# SUBMISSION FROM INNER WEST COUNCIL TO THE DEPARTMENT OF PLANNING, INDUSTRY & ENVIRONMENT OPPOSING THE PROPOSED WESTCONNEX STAGE 3 (M4-M5 LINK – ROZELLE INTERCHANGE) - SSI-7485-MOD-2

#### **SEPTEMBER 2019**

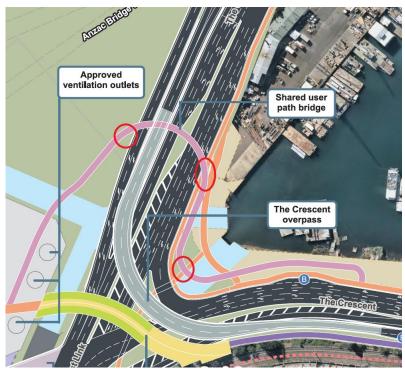
- 7. On the proposed shared user path, stairs be provided to minimise unnecessarily long and circuitous walking distances and provide an opportunity for people to exit the overbridge quickly and gain the attention of passing motorists if they feel unsafe.

Suggested stair locations are shown below and should account for future pedestrian movements resulting from revitalisation of the Bays Precinct. The connections should be legible and direct to provide faster walking access for people who can use them.
